RECEIPT DATE: 12/13/17 **ON-SITE SEWAGE DISPOSAL SYSTEM** P 562359-B
 APPROVAL DATE: 01/05/2018 **PERMIT: CONSTRUCTION** A _____
 PROPERTY ADDRESS: 8441 Parecco Drive
 SUBDIVISION: Beaufort Estates LOT: 3 TAX ID: 05-413818
 CONTRACTOR: South Carroll Backhoe EMAIL: scbackhoe@comcast.com
 CONTRACTOR ADDRESS: 4410 Salem Bottom Road, Westminster, MD 21157 PHONE: 410-596-3618
 PROPERTY OWNER: Xue Jue and Liu Xiaonong EMAIL: _____
 OWNER ADDRESS: 6505 Tipperany Court, Clarksville, MD 21029 PHONE: _____
 SEPTIC TANK SIZE (GALLONS): 2000 TANK MANUFACTURER: Mayer Bros
 PUMP MODEL: N/A PUMP SIZE N/A PUMP TANK CAPACITY: N/A

DATE <u>7/11/17</u>	PROJECT No. <u>2687</u>
ATTENTION <u>Hank Oswald</u>	
RE: <u>Beaufort Estates Lot 3</u>	
<u>8441 Parreco Dr.</u>	
<u>Revised OSDS Plan</u>

OSDS Plan
8441 Parreco Drive
Fulton, MD 20759

The OSDS Plan for Beaufort Estates, Lot 3 has been reviewed with the following comments:

TRENCH/DRAINFIELD DATA

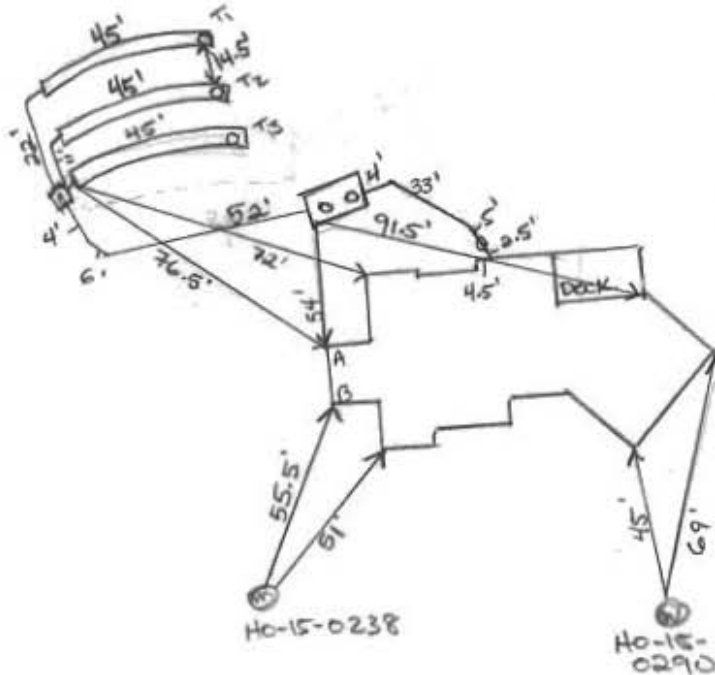
3/28/2018 Ammended layout to optimize SDA and make fall to 2nd Rep Sys.
 Relocated D box to mid upper edge of SDA. 3 x 45' Trenches for 135 linear.
 Tank shifted toward house, still meets 20' setback @

PLAN VIEW
1" = 50'

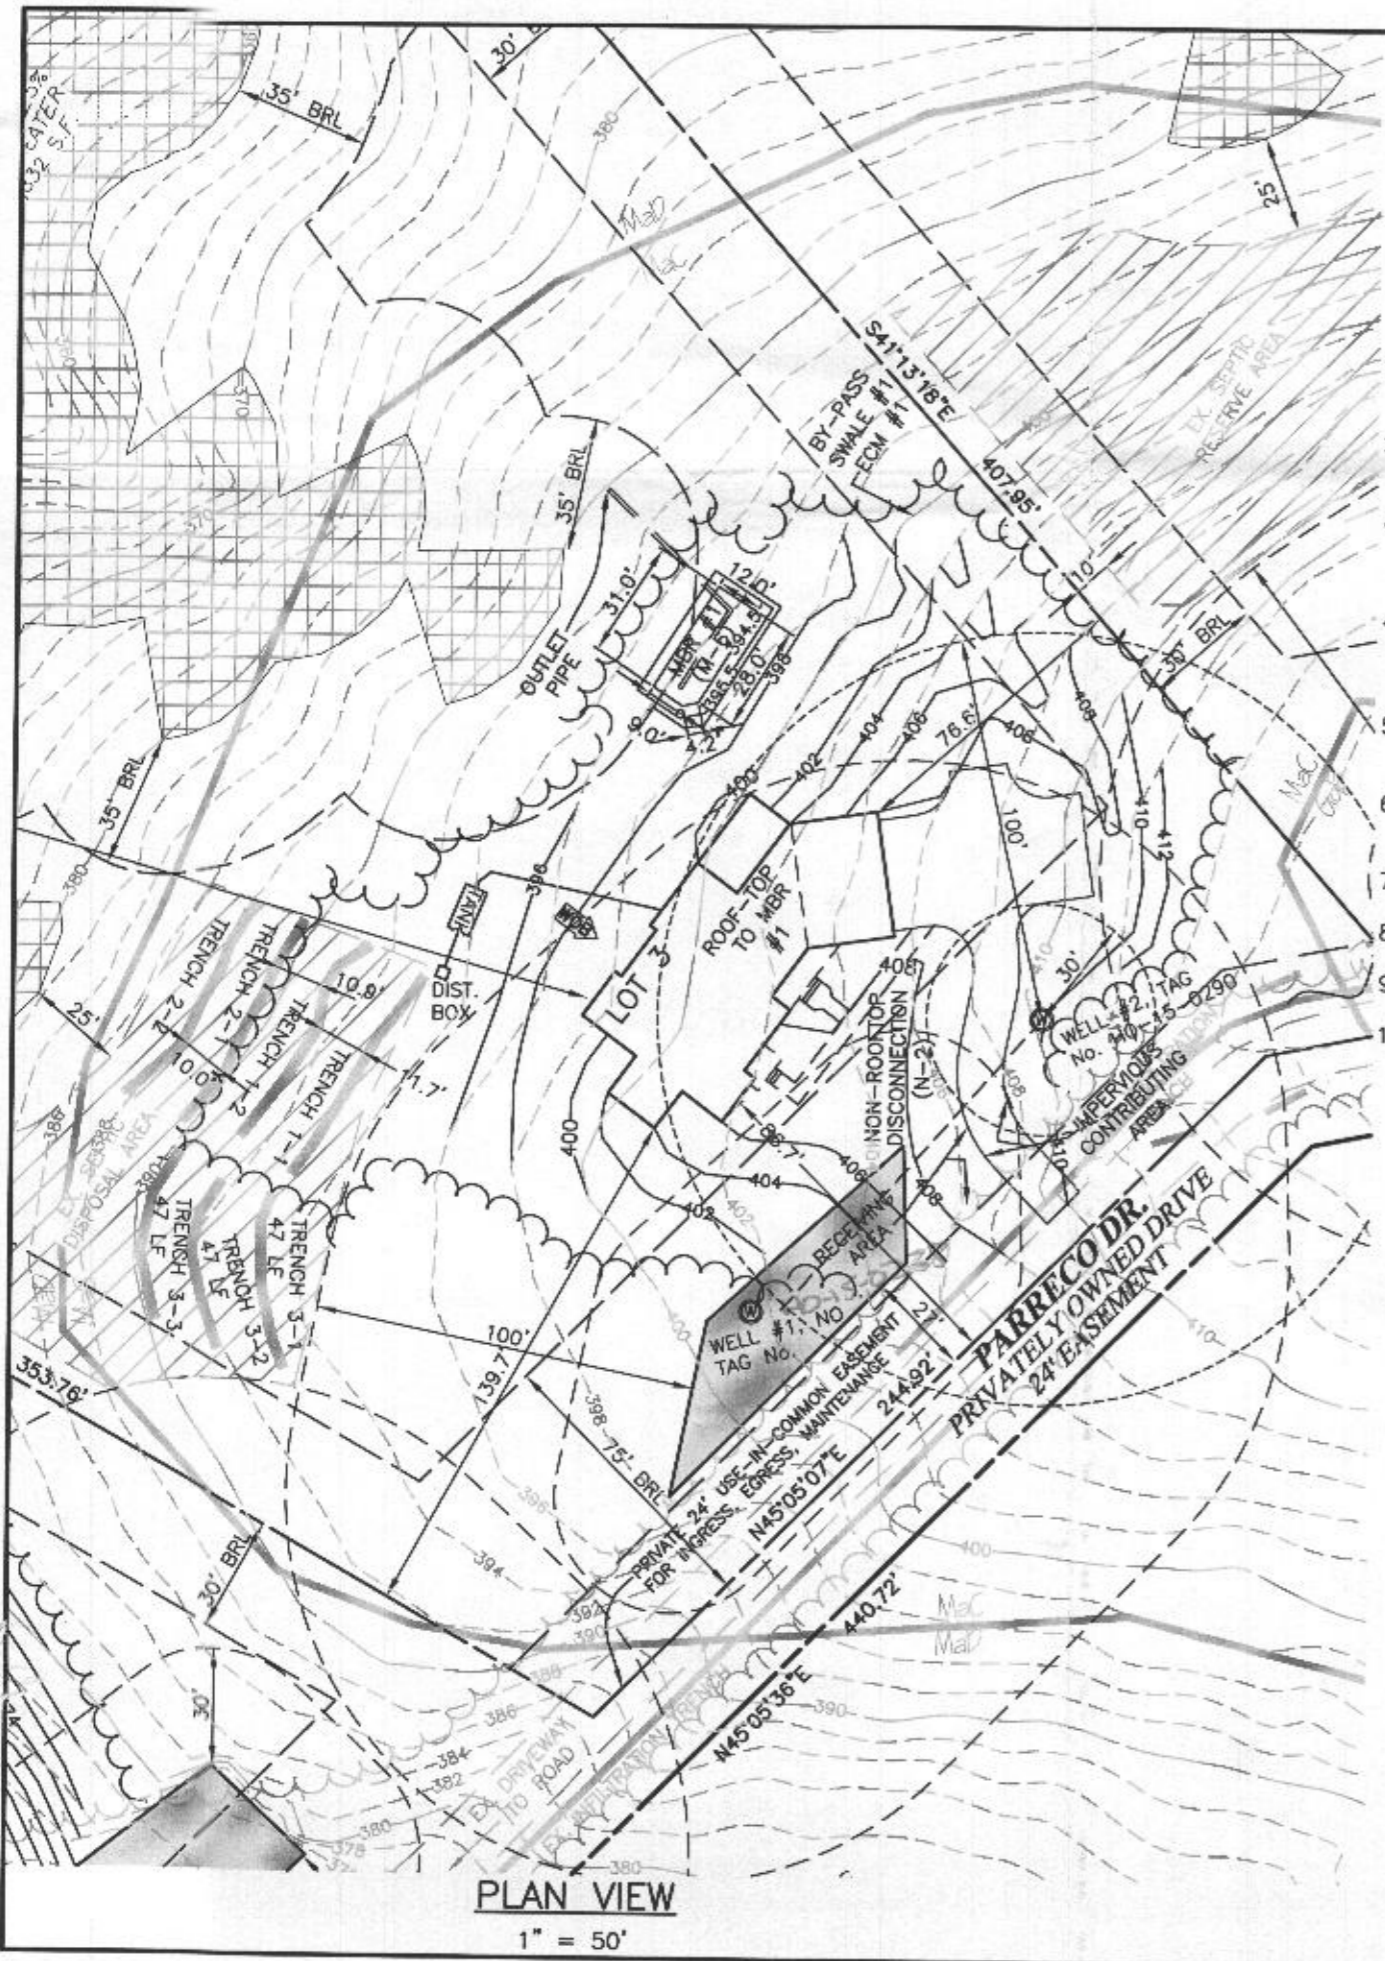
- 1.) Add both well locations & well tag #s.
- 2.) Change note #6 to include both well tag #s.
- 3.) Add note that basically states that both wells will be tied in together to serve the house.
- 4.) Show 3rd system and calculations

5. ALL DRAINAGE AND STORMWATER MANAGEMENT FEATURES USED ON THIS SITE MUST COMPLY WITH THE APPROVED ROAD CONSTRUCTION PLANS EXCEPT AS WAIVED.
6. THE EXISTING WELLS SHOWN ON THIS PLAN, WELL #1 NO TAG 40-15-0238 AND WELL #2, TAG No. HO-15-0290, HAVE BEEN FIELD LOCATED BY BENCHMARK ENGINEERING, INC., AND ARE ACCURATELY SHOWN.

9. STORMWATER MANAGEMENT FOR THIS LOT WAS DESIGNED TO BE PROVIDED BY BOTH POND #1, A POCKET POND, AND IN POND #2, A MICROPOL ED POND.
10. THE SUPPLY LINES FROM WELLS #1 AND #2 SHALL BE TIED TOGETHER IN ORDER TO PROVIDE ADEQUATE SERVICE TO THE HOUSE. TIE LOCATIONS SHALL BE NOTED AND PROVIDED TO THE OWNER.
